Your Ref: SSD - 93020230

**OBJECTION TO SSD 93020230 40-48 REDAN STREET, MOSMAN
PROPOSED DEMOLITION WORKS AND CONSTRUCTION OF A PART 10-STOREY AND
PART 5-STOREY PROPOSED RESIDENTIAL FLAT BUILDING CONTAINING 53
RESIDENTIAL DWELLINGS (INCLUDING 11 AFFORDABLE HOUSING UNITS) WITH 2
LEVELS OF BASEMENT PARKING CONTAINING 106 RESIDENT PARKING SPACES
APPLICANT: MOSMAN LAND NO. 1 PTY LTD**

State Planning Services Pty Limited (**SPS**) has been commissioned by Mr Scott Wehl, owner of No. 52 Almora Street, Mosman (**our client**) to provide an independent town planning assessment of SSD 93020230 (**the proposal**) at Nos. 40-48 Redan Street, Mosman (**the site**).

Figure 6 Base Extract from JMT Consulting TIA with Walking Route to Mosman Town Centre – Incorrectly Calculated

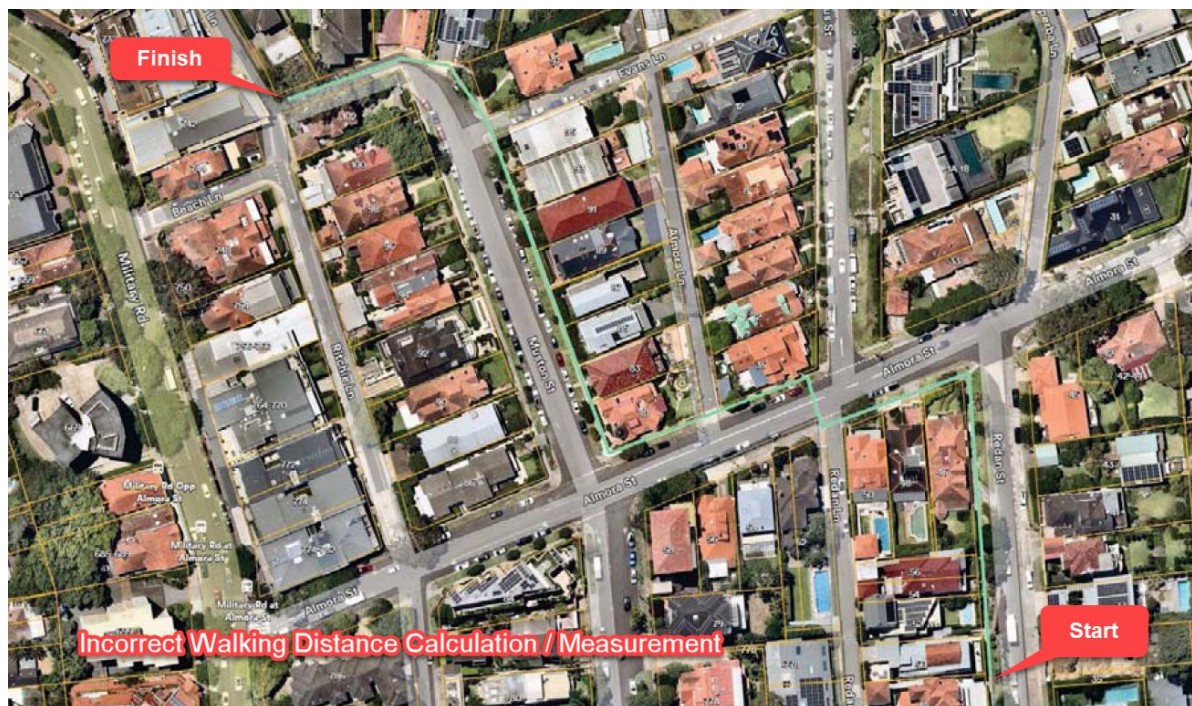
The Applicant's Traffic Impact Assessment (**TIA**) prepared by JMT Consulting outlines the 'Walking route to Mosman Town Centre' (Figure 13/Page 16) which shows the route relied upon marked in green (**Figure 6**):

JMT Consulting describes the route in the TIA and states '*As advised by LTS Surveyors this walking route has a total distance of 394.7m to the nearest 0.1m.*' Although the walking route assessment in the TIA does not rely upon Redan Lane, the measurement of 394.7m is incorrect as the correct measurement of the green line in Figure 13 of the TIA is 404m (**Figure 7**).

The LTS Surveyors walking route is not provided with the EIS, but in any event, an actual walk of the green line route adopted by the application reveals that this route is neither conducive to being safely walked (including stairs and other obstacles such as parked cars), nor compliant with the definition of 'walking distance in schedule 10 of the Housing SEPP.

Although the TIA does not purport to rely upon Redan Lane as part of any walking route, the EIS nevertheless appears to rely upon an incorrect measurement of 394.7 metres, which has been used to falsely characterise the site as falling within a 'low and mid rise housing inner area' (as defined).

Figure 9 Spit Junction Town Centres map – Extract with SPS Mark-up in red

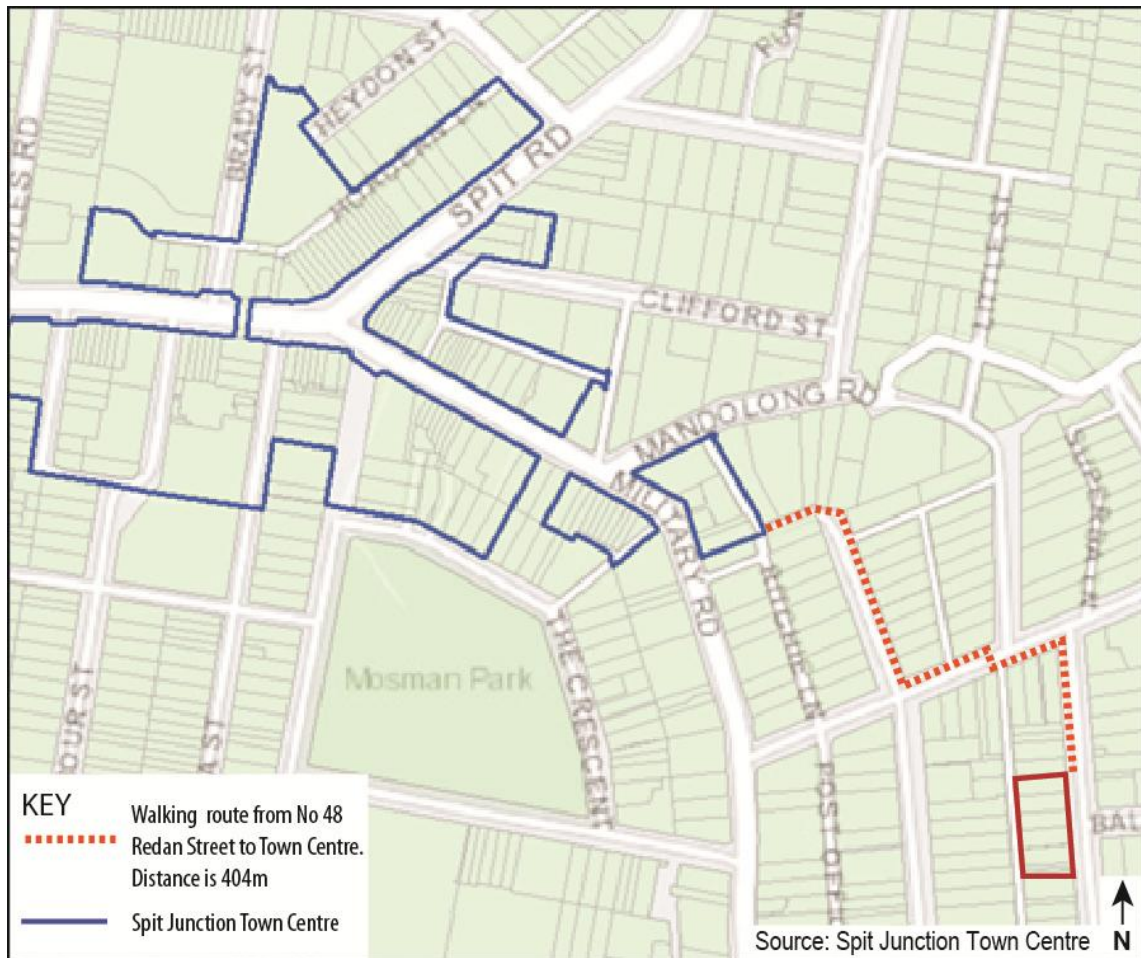
Figure 9 indicates an extract from the ‘town centres map’ which identifies Spit Junction Town Centre relative to the location of the subject site.

Whilst the site is within a low and mid rise housing area, it exceeds 400m 'walking distance' of the Spit Junction Town Centre and therefore is appropriately categorised as a low and mid rise housing outer area.

Even without using the available pedestrian crossing and by disregarding slope, the site is measured well in excess of 400m from the edge of the nominated Spit Junction Town Centre via the footpaths that can be safely walked by a pedestrian to the Redan Street frontage.

If the route above is amended to include use of the pedestrian crossing and the slope of the footpaths is also factored in to the calculation, the distance measured increases considerably. Given that Section 163 of the Housing SEPP is directed to “walking distance”, there is at least scope to argue that the measurement should not be taken from the closest part of the site to the closest part of a Spit Junction Town Centre, but from the pedestrian entry and exit location of the proposed development on the site to the entry point of the Spit Junction Town Centre itself (as distinct from the boundary of the Spit Junction Town Centre).

Figure 10 – The Mosman LEP 'Scenic Protection Area' bisects the site. (Source: MLEP 2012)

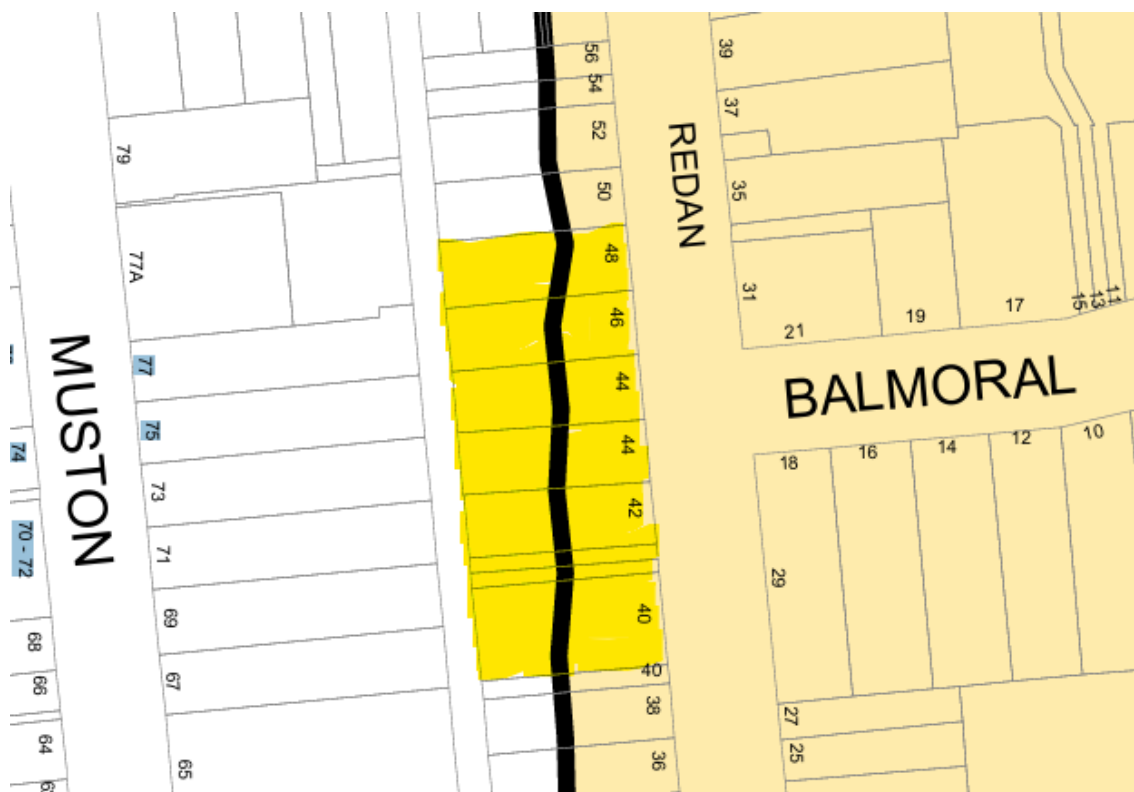
In addition to the site being at the interface between the two zones with the need to be considered as a transitional site, the eastern part of the site is also within the MLEP Scenic Protection Area (Figure 10).

The proposed 10 storey development, with building height and number of storey non-compliances does not protect the natural and visual environment, but rather reinforces the dominance of built form over landscape (the opposite of the objectives). The development also does not maintain the existing natural landscape and more particularly, the landform.

Figure 11 Mark-up of East Elevation from Architectural Plan set – FJC Studio

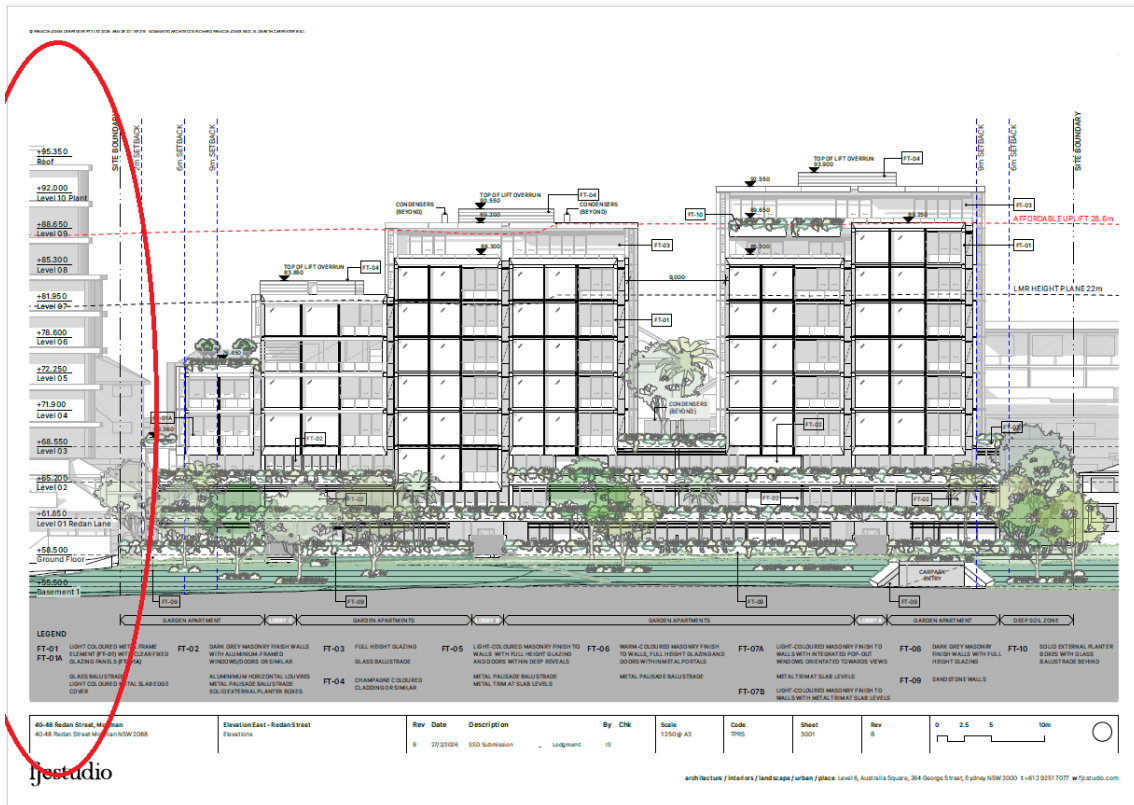
When viewed from the front of the site in Redan Street, the East Elevation drawing in the Architectural Plan set prepared by FJC Studio incorrectly shows a taller building to the left side of the site (i.e. to the south), yet there has been no approval granted for any such building (**Figure 11**).

SPS is aware of another proposal for a considerably lower building (i.e. 4 storeys) as part of DA8.2025.235.1 which was refused on 18 February 2026. **Figure 11** shows buildings of comparable height surrounding the proposal when neither such building exists, nor has been approved.

Information on the Architectural Plan elevations is misleading, as it attempts to incorrectly portray the development as being consistent with the existing character of residential development in this location of Mosman (or with recently-approved development) – which it is not.

Figure 13 Development site (green) and its relationship to surrounding heritage items (Source MLEP)

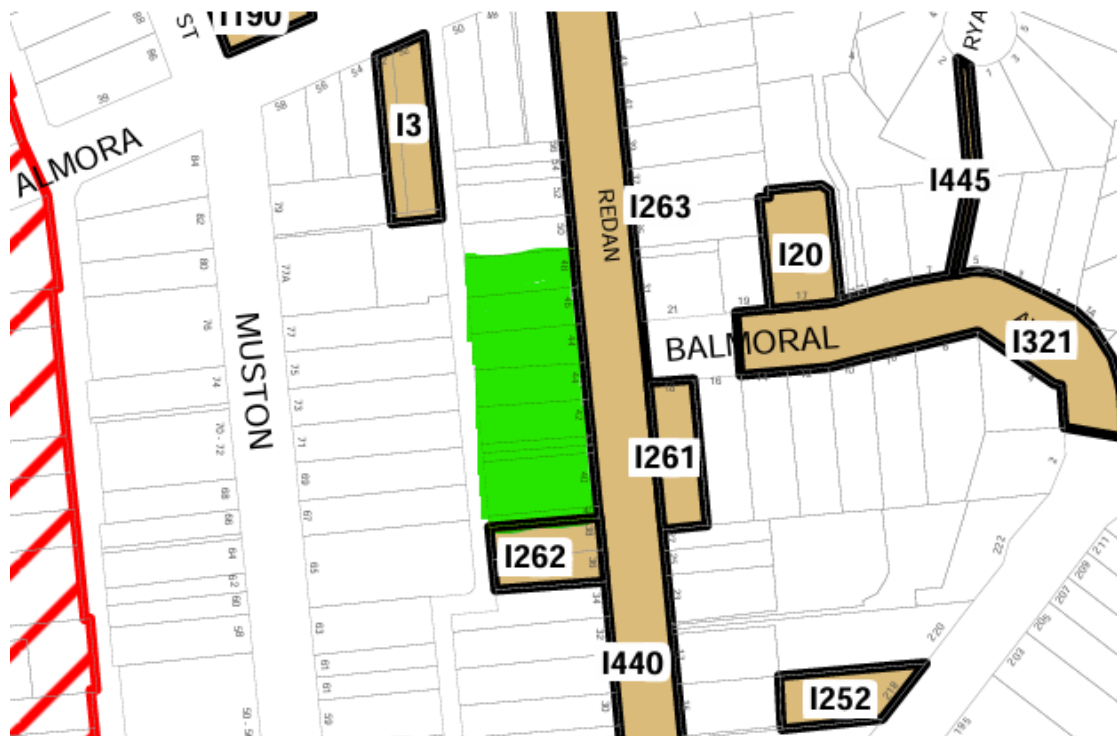
The site has a number heritage items located within the surrounding locality as recognised under Schedule 5 of MLEP, including (Figure 13):

If the proposal is constructed in its current form there will be insufficient distance separation between the heritage items to allow for a part 5-storey part 10 storey building and appropriate transition heights between the sites. The proposal includes a 10-storey residential flat building element that is considerably higher than the existing development on the site and also considerably higher than any other development in this location which consists of buildings up to 2 storeys in height.

Figure 14 Proposed Vehicular Access onto Heritage-listed Road Reserve (Redan Street)

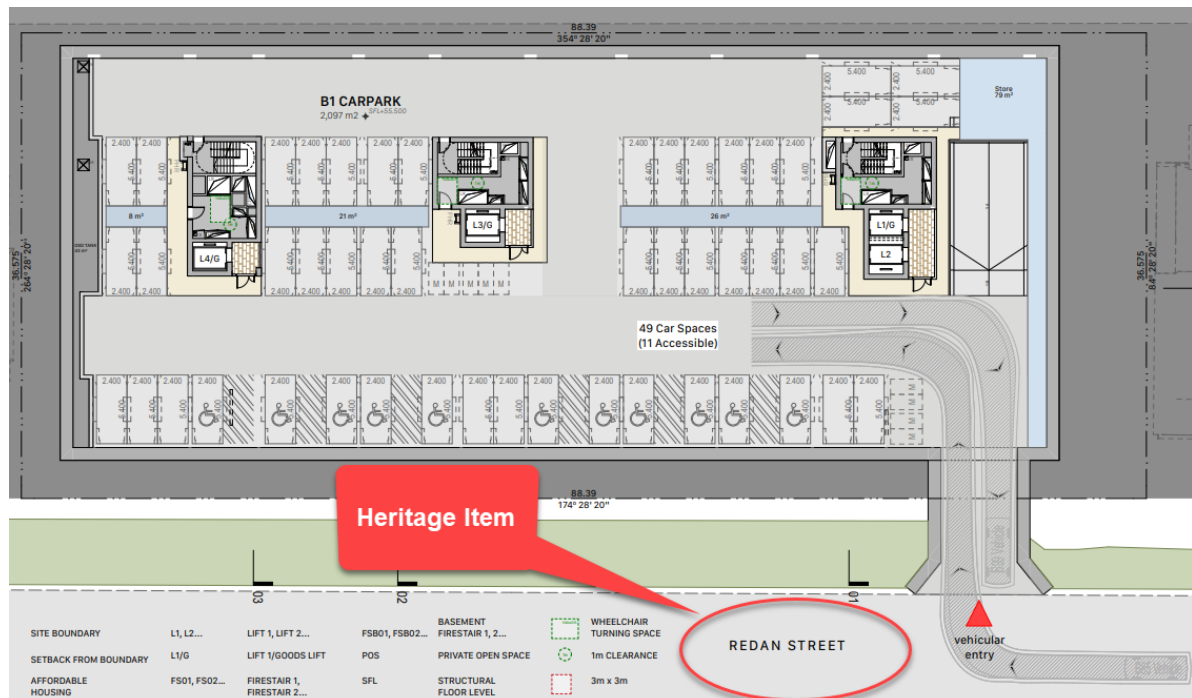
Redan Street has a carriageway that has a significant rock wall and landscaped embankment. The road narrows to the south where the character of the road is more evident with the significant rock wall and pedestrian pathway being at a different level from the carriageway. The proposal to include access to 106 car parking spaces from Redan Street disregards the heritage significance of this road reserve and indicates that the site is unsuitable for the development (**Figure 14**).

Figure 18 Section of the development (Source: Clause 4.6 Variation Request Building Height, prepared by Urbis)

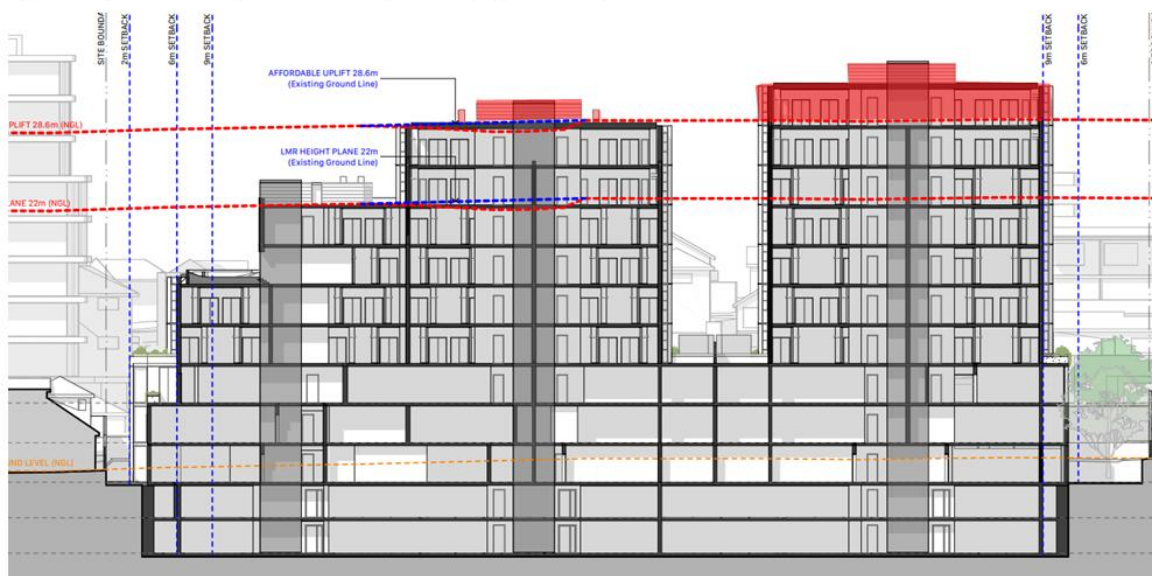
The proposed breach to the Housing SEPP height controls to the extent shown in Figure 18 is both excessive and unreasonable, even putting aside our opinion that the incorrect base height/FSR controls have been relied upon in the Housing SEPP.

Figure 18 indicates that the proposed development will benefit from an additional storey on the northern tower.
